PRAIRIE ISLAND INDIAN COMMUNITY
LEGAL DEPARTMENT

RE: Prairie Island Independent Spent Fuel Storage Installation Proposed License
Renewal (Docket 72-10)

Prairie Island Indian Community Comments Regarding Section 106 Consultation

FIGURE 1

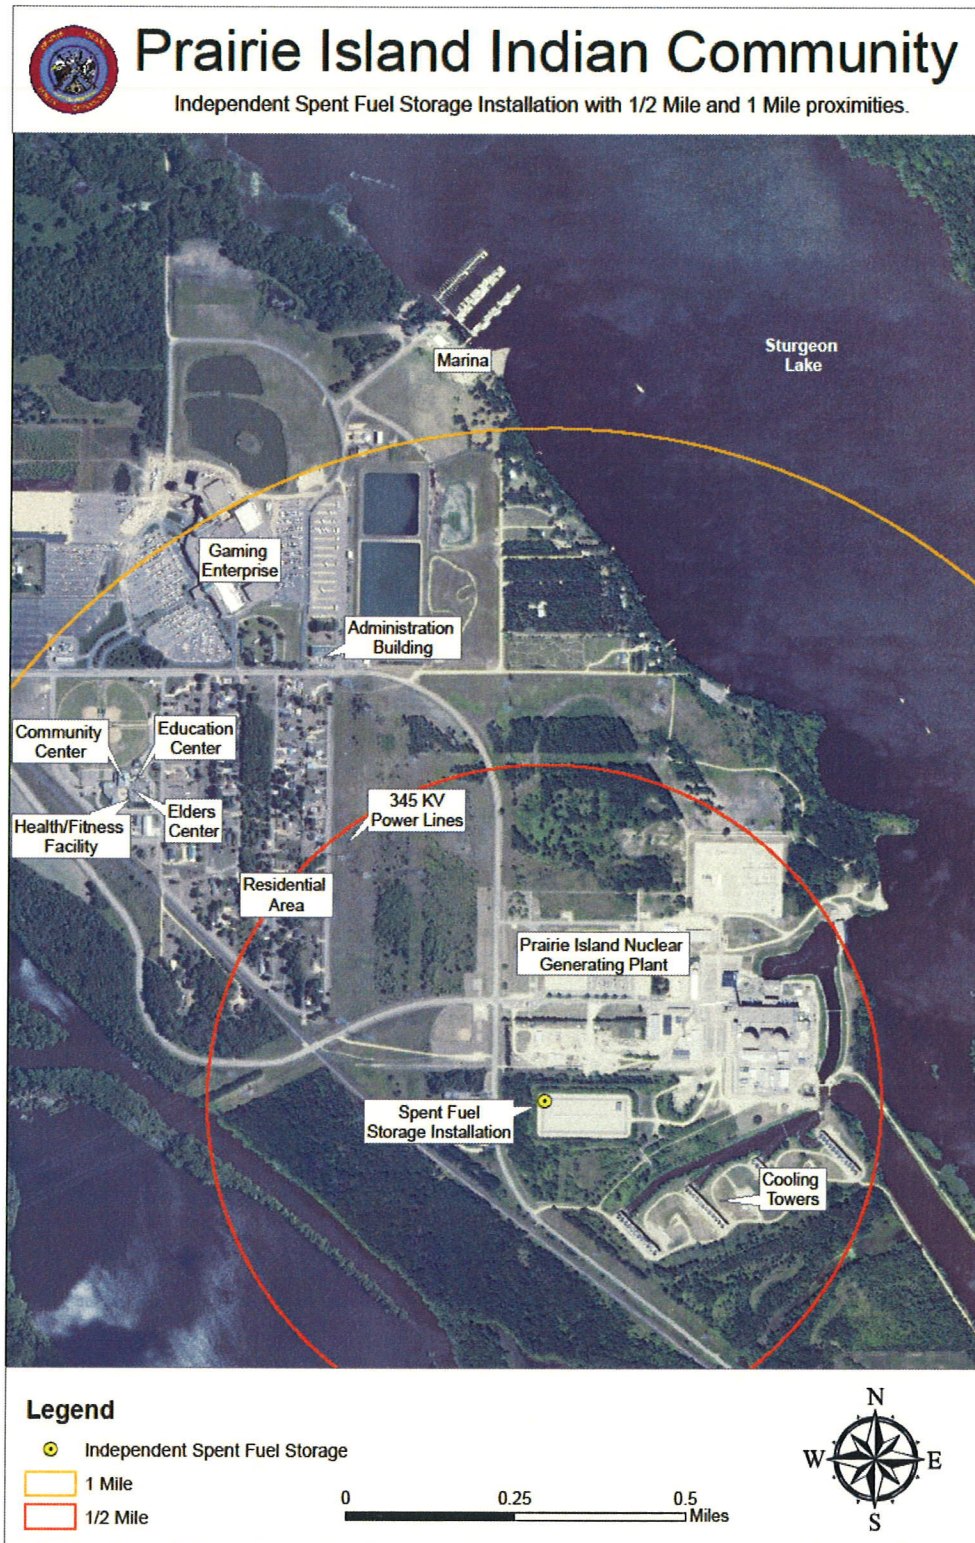
The Prairie Island Nuclear Generating Plant ("PINGP"), owned by Northern States Power Company, a Minnesota corporation, d/b/a Xcel Energy ("NSPM"), is also located on Mdewakanton Dakota ancestral lands and immediately adjacent to the Prairie Island Indian Community Reservation. The PINGP's Independent Spent Fuel Storage Installation ("ISFSI") is approximately 600 yards from the nearest Community residences. *See* Figure 1 on Page 2.

To our knowledge, there is no community closer to an ISFSI than ours. If the PINGP is decommissioned in 2034, the spent nuclear fuel will require a total of 98 casks.
